GOVERNMENT OF THE DISTRICT OF COLUMBIA
DEPARTMENT OF TRANSPORTATION

MEMORANDUM

SUBJECT: Zoning Commission Case No. 15-03 – 1315 Clifton Street NW

Figure 1 - Site Design and Access (Source: Gorove/Slade)

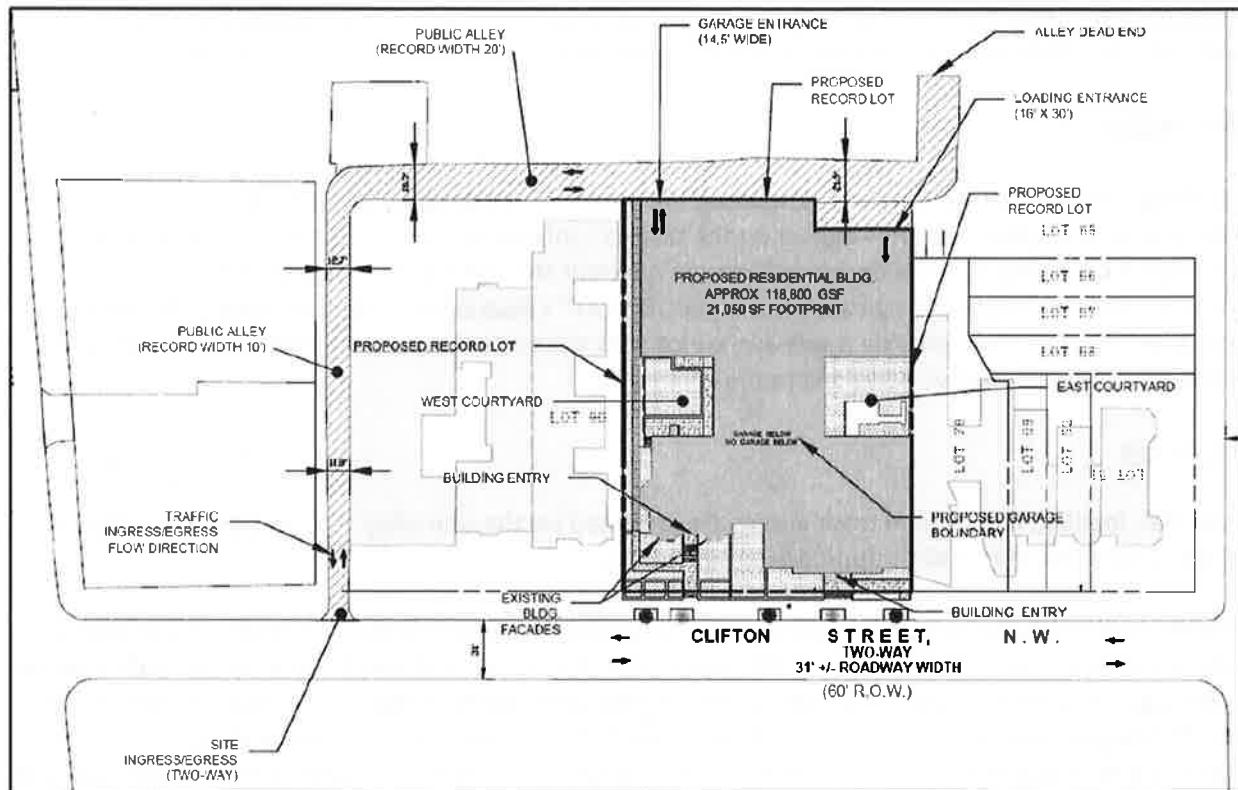
Vehicular, loading, bicycle, and trash access are proposed via the rear alley. The proposed site access location complies with DDOT's approach to site access.

Of note, constraints caused by the width of the alley network serve to limit the size of vehicles that are able to access the rear of the property. The site is served by an alley network that contains both a north-south segment connecting to Clifton Street and an east-west segment that terminates just east of the site. The only access point to the alley network is via Clifton Street. The north-south alignment of the alley has a recorded width of 10 feet while the east-west alignment has a recorded width of 20 feet. The narrow north-south segment of the alley serves to limit access to trucks of about 24 feet in length and shorter and also prohibits simultaneous two-way circulation. The Applicant has identified potential traffic operations management measures, including mirrors, to regulate the use of the alley network, and the Applicant is expected to coordinate with DDOT through the permitting process to evaluate and implement potential management strategies for the alley.

A single 24-foot loading berth is proposed at the rear of the building. The Applicant's proposed loading locations comply with DDOT's loading requirements. The Applicant's analysis includes AutoTurn analysis showing that truck maneuvers can be accommodated with front-in/front-out movements, in keeping with DDOT standards.

The Applicant is seeking relief from the 55-foot loading dock and the 20-foot service space. As noted in the Site Access section, the narrowness of the alley constrains access to the alley network to trucks larger than about 24 feet in length.

- Limit the size of trash trucks servicing the site to trucks that can operate within the alley with head-in/head-out movements

The Applicant would need to perform truck turning analysis to determine the maximum size truck that can service the site and coordinate with the trash service provider to ensure that appropriately sized trash trucks are secured to service the site.
